ALERT SERVICE BULLETIN

Exchange of exhaust valves on ROTAX® Engine Types 915 i A, 915 i B (Series) and 914 (Series)

Exchange of exhaust valves on ROTAX Engine Type 915 i A, 915 i B (Series) and 914 (Series).

Fig. 2
Identification of exhaust valves

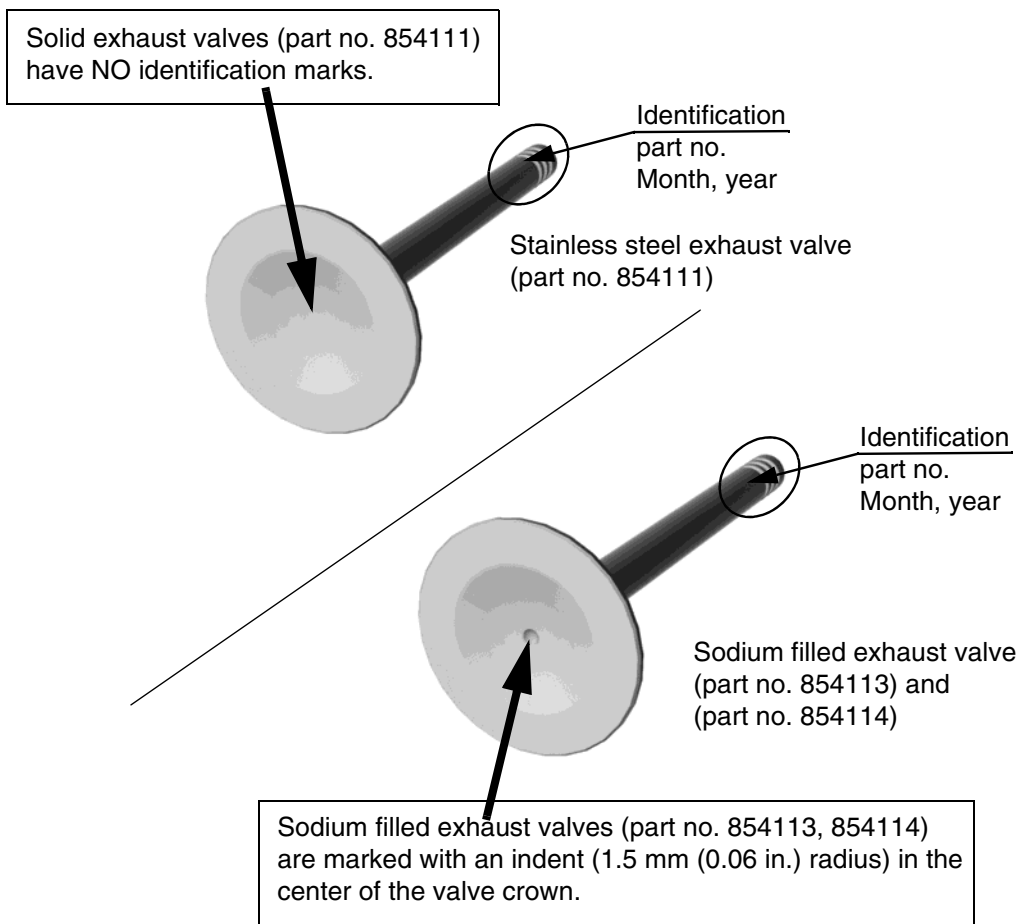
Due to deviations in the manufacturing process of the exhaust valve 32 mm (1.26 in.) with part no. 854113 an exhaust valve cracking / fracture may occur. In consequence this may result in a malfunction of the valve train and a subsequent engine stoppage.

Exchange exhaust valves part no. 854113 for part no. 854114 in accordance to relevant Maintenance Manual Heavy.
